To: Mr. Dennis G. Walsh - Klein, Thorpe, and Jenkins, Ltd.  
From: Aptim Environmental and Infrastructure and Walter Willis  
Date: August 27, 2020  
Re: West DuPage Recycling and Transfer Station Draft Siting Application Review

On behalf of the City of West Chicago, APTIM Environmental and Infrastructure LLC (Aptim) and Walter Willis have completed a review of the updated Draft of the Siting Application (Application) for the Lakeshore Recycling System, LLC (Applicant) West DuPage Recycling and Transfer Station, prepared by Civil and Environmental Consultants, Inc. (CEC). Upon review of the updated Draft, concerns regarding the applicant content and several siting criteria were identified and are summarized below:

Figure 1

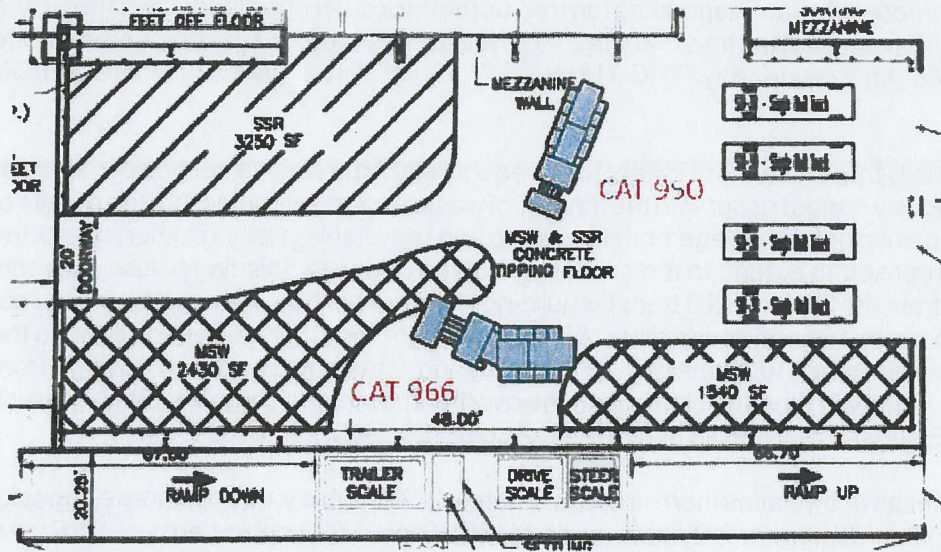
The wheel loaders that are depicted on Figure 2-3 are drawn at a smaller scale than actual size. The loader models being used at Lakeshore's California Ave facility are Caterpillar 980 and 950 for loading and consolidation, respectively. **THE DIMENSIONS OF THE PLANNED LOADERS HAAVE BEEN ADDED TO FIGURE 2-3** The smallest loader recommended by Caterpillar for use in a transfer station that transfers 1,300 tons per day (MSW and SSR) is a 966 model with an 8.5 yd bucket, though an even larger 980 model may be necessary as it apparently is at the California Ave. facility. The 966 and 950 models have lengths of almost 27 feet (without a bucket) and widths of 9.83 and 10.83 feet over tires, respectively. **THE DIMENSIONS ARE SHOWN ON FIGURE 2-3** The loaders shown appear to have length of only approximately 17 feet (without bucket) and a width of approximately 7 feet over tires. Figure 1 imposes more realistic loaders onto the Applicant's Figure 2-3.

As shown, the sizes and locations of the stockpiles create a limited area where the wheel loaders can operate and will prevent a wheel loader from unloading and loading a transfer vehicle as efficiently as presented.

Figure 2

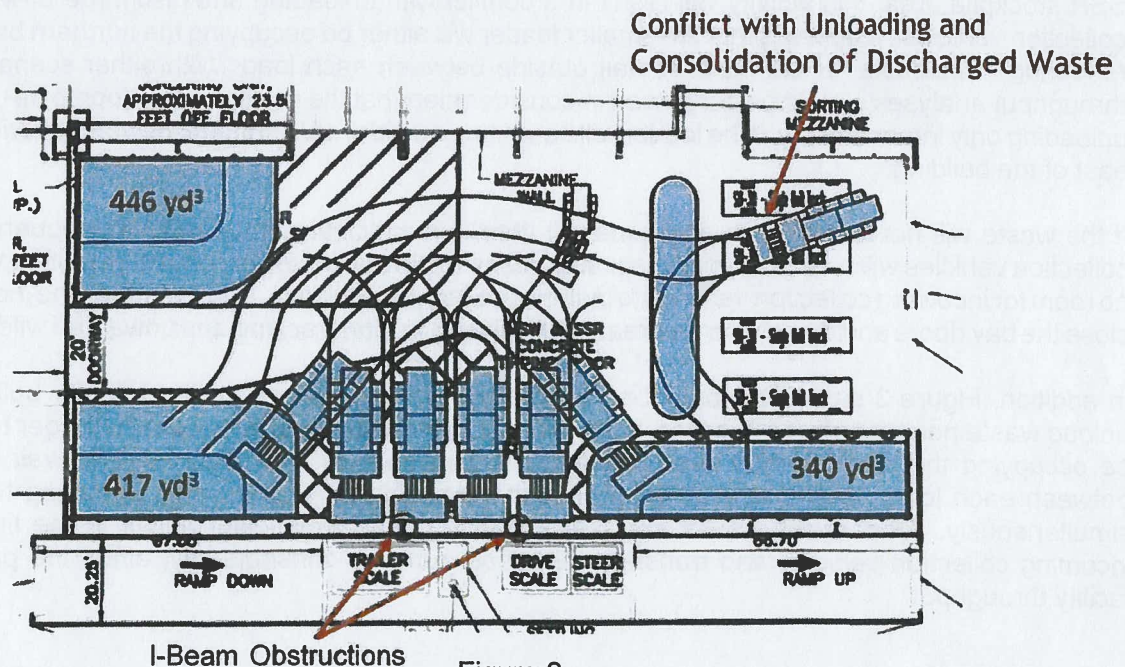
The applicant should provide analyses of the area required on the floor to allow movement of the appropriately sized wheel loaders to accommodate the corresponding turning radius (both for pushing unloaded waste into the pile and loading a transfer vehicle) and how that affects the area available on the floor to store waste. **THE TURNING RADIUS OF THE 980 LOADER IS SHOWN ON FIGURE 2-3 TO DEMONSTRATE THE APPROXIMATELY WORKING AREA FOR THE LOADER.** The current scenario appears not to allow these movements as depicted in Figure 2.

Figure 2 illustrates more realistic stockpile sizes, each showing a 1:1 working face up to the top of the pushwall (a height of 12 feet) while still allowing relatively free maneuvering of the loaders. It also shows more realistic stockpile sizes. Using the average areas of the pile bases and plateaus on this figure and multiplying by 12 feet, we estimate the total volume of MSW and SSR storage is only 757 cubic yards and 446 cubic yards, respectively.

Figure 2 also illustrates a previously mentioned issue of the need for waste to be consolidated from its discharge area to the southwest stockpile. In addition to the previously described need to reduce the SSR stockpile area, this activity will result in a conflict with unloading and discharge of waste by collection vehicles. It appears that the smaller loader will either be occupying the northern bay door, rendering it unusable, or will have to wait outside between each load. With either scenario, the throughput analyses should be performed in consideration that the northern bay door to be used for unloading only intermittently. If the loader will be waiting outside, it will impede the maneuvering area east of the building.

Drawing C302 and Figure 2-3 both show I beam column supports in front of the loading bay which will prevent (or severely inhibit) the ability to load trailers. These obstructions are identified on Figure 2 of this memorandum. **THE DRAWING AND FIGURES ARE CORRECT. THE COLUMNS SHOWN ARE PRESENT ABOVE THE LOADING PIT FRAMED OPENING. AN ELEVATION VIEW WAS ADDED TO THE DRAWING SET TO SHOW THE BUILDING FRAMING. THE COLUMNS WERE REMOVED FROM THIS LOCATION ON CERTAIN FIGURES TO AVOID CONFUSION.**

wheel loader or accommodate the corresponding turn radius (both for pushing unloaded waste into the pile and loading a transfer vehicle) and how that will affect the area available on the floor to store waste and the required maximum tons per day. **THE TURN RADIUS OF THE LOADER IS SHOWN ON FIGURE 2-3.**

Figure 3

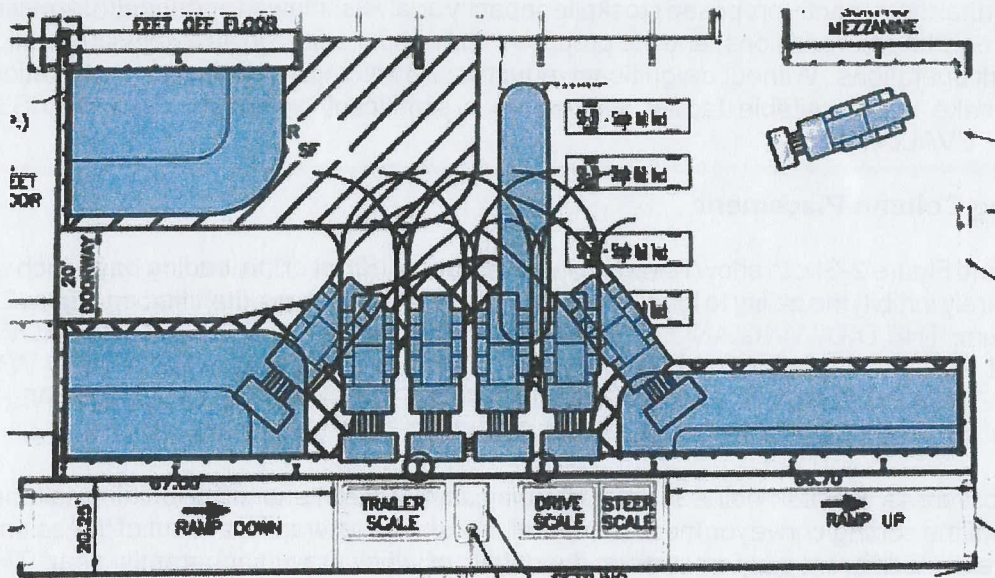
In addition, Figure 3 shows the collection vehicle pulling far enough into the transfer building to unload waste near the stockpile areas, but in doing so, will also require the smaller loader to either be occupying the northern bay door, rendering it unusable, or that it will have to wait outside between each load. This scenario also makes it impossible for loading and unloading to occur simultaneously. All of these issues are anticipated to cause significant delays in the timing of incoming collection vehicles and transfer trailer load-out and, consequently, affect the proposal facility throughput.

In addition to the apparent need for one of the loaders to be blocking one of the bay doors, it is proposed that four vehicles (two per door) can be unloading at the same time. The doors are specified to be 30 feet wide, each. Assuming a width of 10 feet for each truck, **THE MAXIMUM LEGAL VEHICLE WIDTH IN ILLINOIS IS 8.5 FEET**, there will only be approximately 3.3 feet of clearance between the doorjamb and/or adjacent truck in each bay. This is unlikely as it will require near perfect driving from collection vehicles in order to reverse through a shared door without causing an accident. At maximum throughput peak hour, the Applicant plans to dump 28 trucks in the building - 14 trucks through each bay in the busiest hour. This will not be possible if only one bay can be used and if two trucks cannot tip their loads simultaneously in each bay. With only one useable bay and one vehicle in that bay at a time, only 12 vehicles will be able to unload if the applicant's assumption of 5 minutes per dumped load is accurate. Aptim has used a range of unloading times of 4 to 9 minutes (average of 6.5 minutes) which would further reduce the number of vehicles that can dump. **WE ARE USING 5 MINUTES AND BELIEVE THAT THIS IS AN APPROPRIATE AVERAGE TIME.**
